NOTICE OF DECISION TO CONSENT TO AMEND A REFERRED PROPOSAL DURING ASSESSMENT

Ridley Magnetite Project
Assessment No. 2362; APP-0000162

Ridley Magnetite Project

Proposal Content Document

Original Proposal - Mine Area

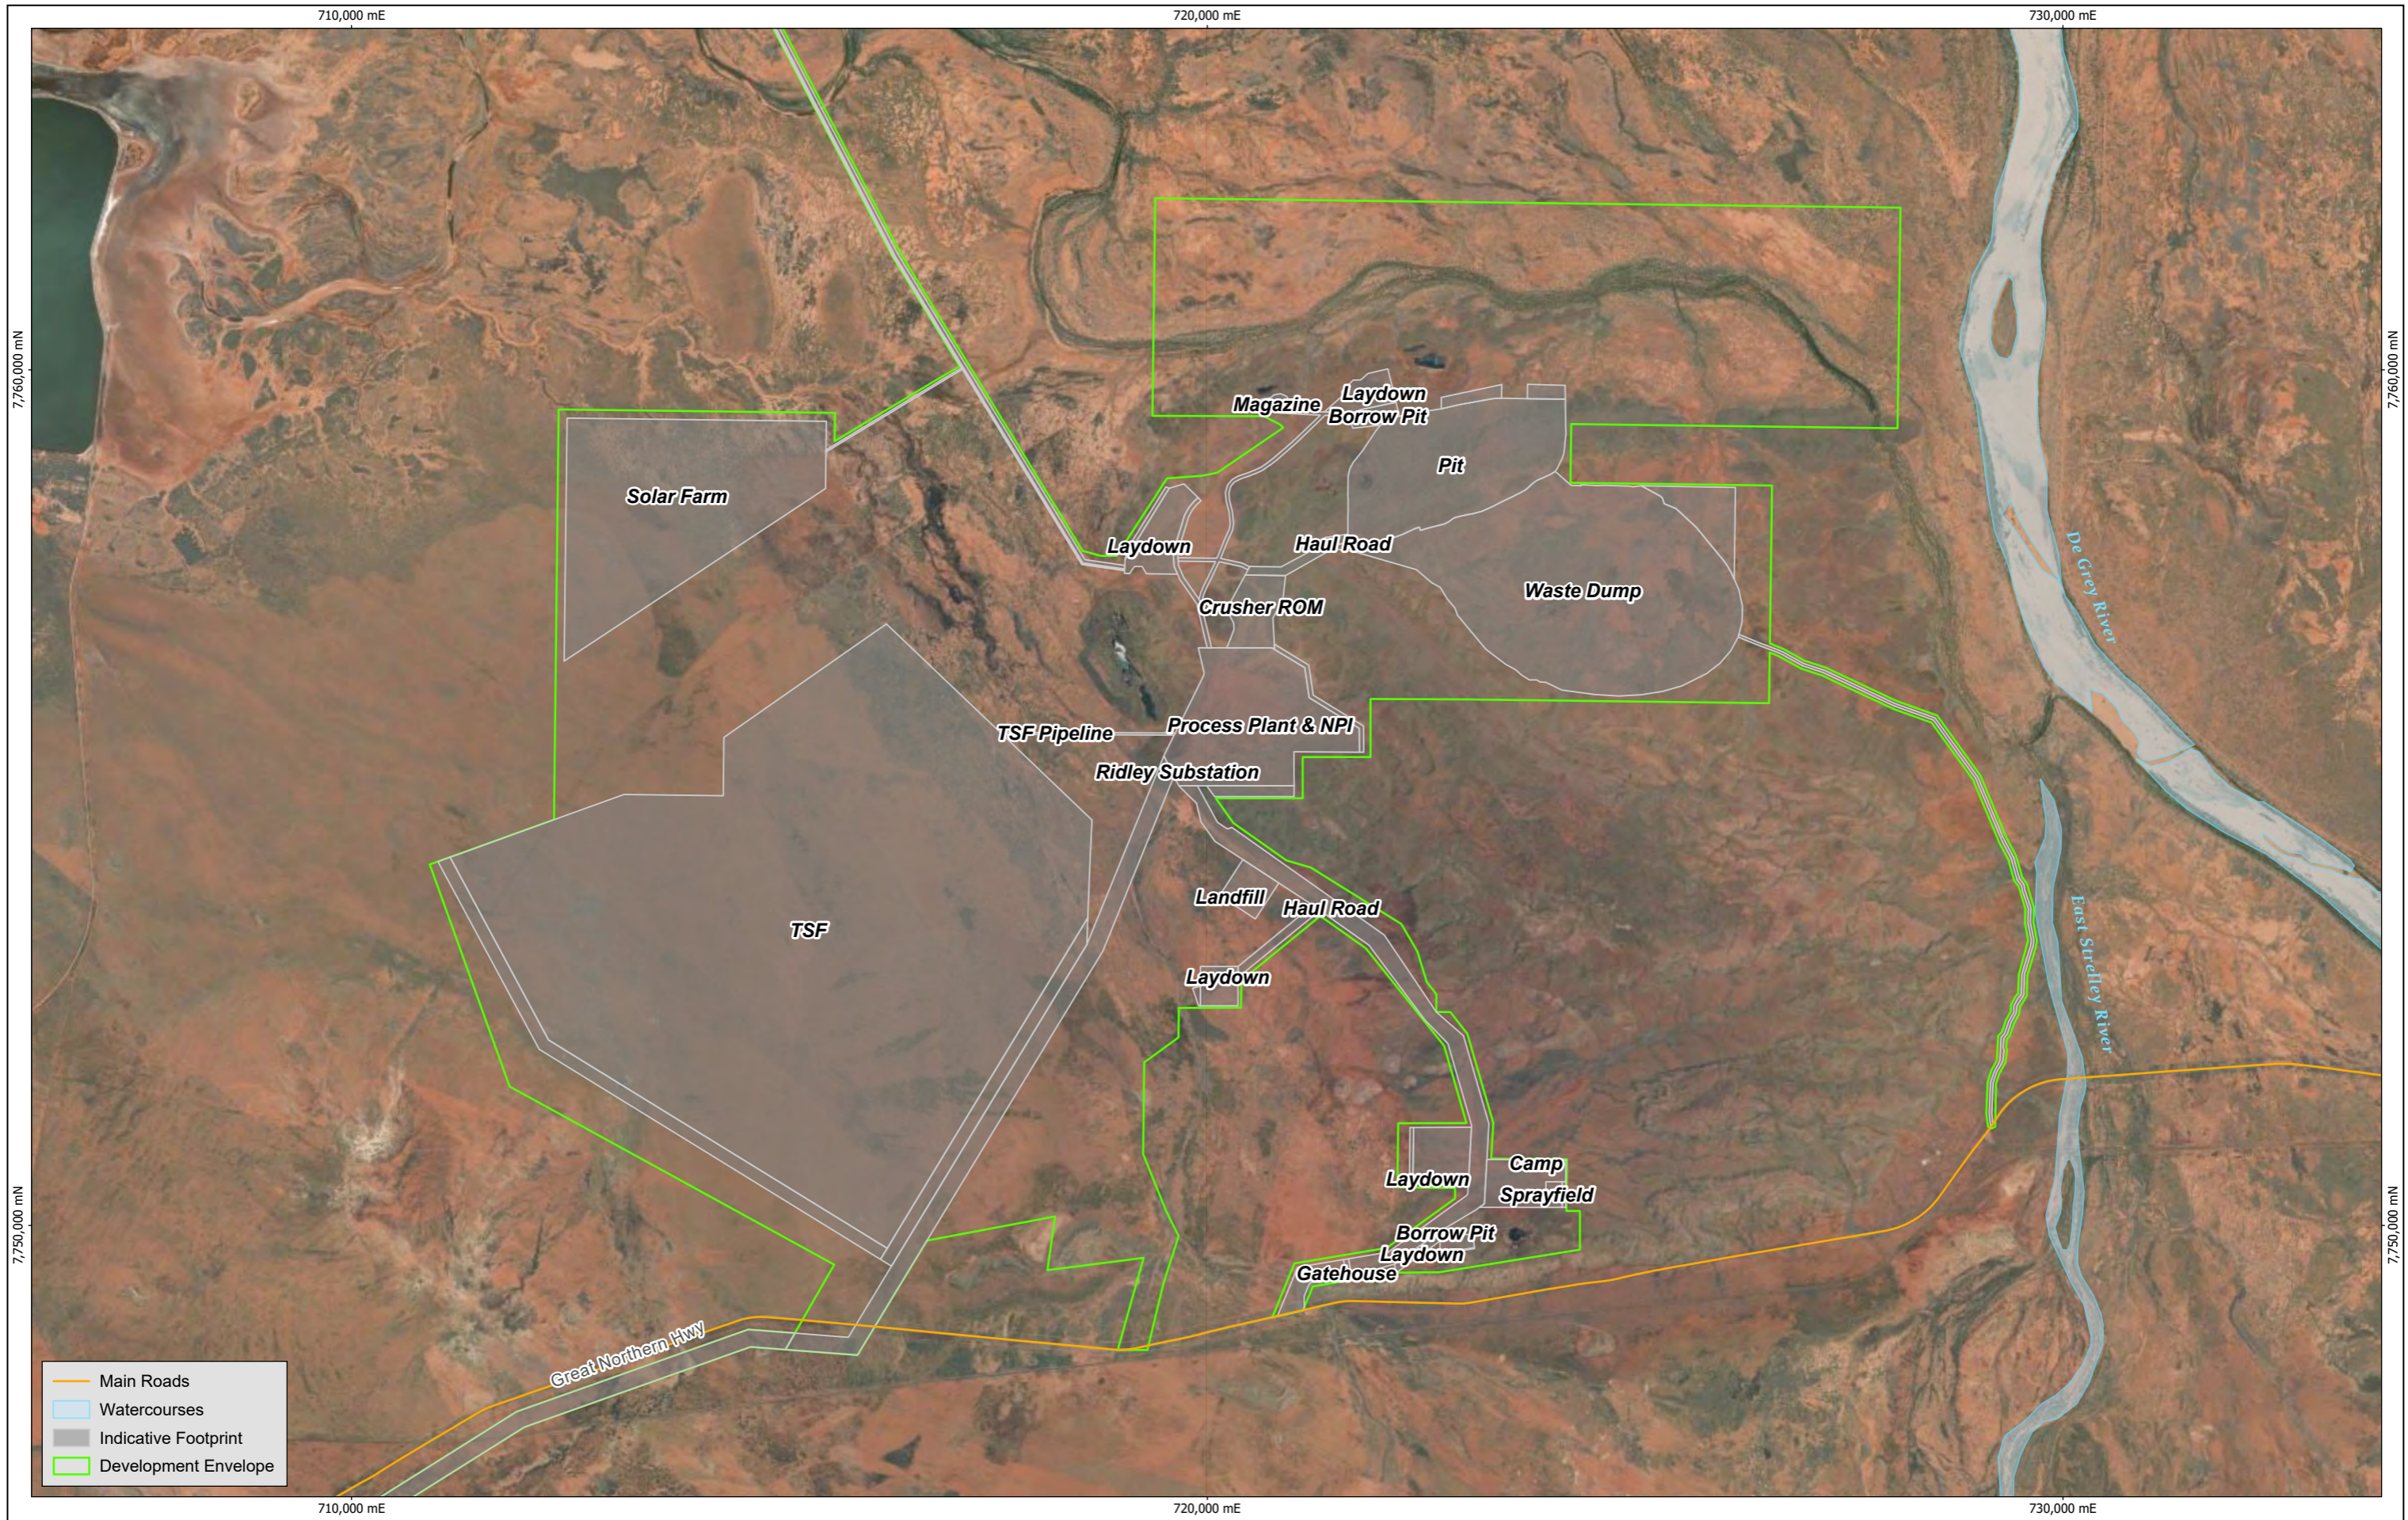
- 297 ha increase due to an increase in the width of the eastern road corridor, to 200 m, and the inclusion of borrow pits along the road alignment.
 - 2,235 ha increase due to changes to the layout of supporting infrastructure, such as the accommodation camp.

- 87 ha increase associated with an increase in the size of the desalination plant.
- Increase the indicative disturbance footprint by 1,078 ha (from 7,406 ha to 8,484 ha).
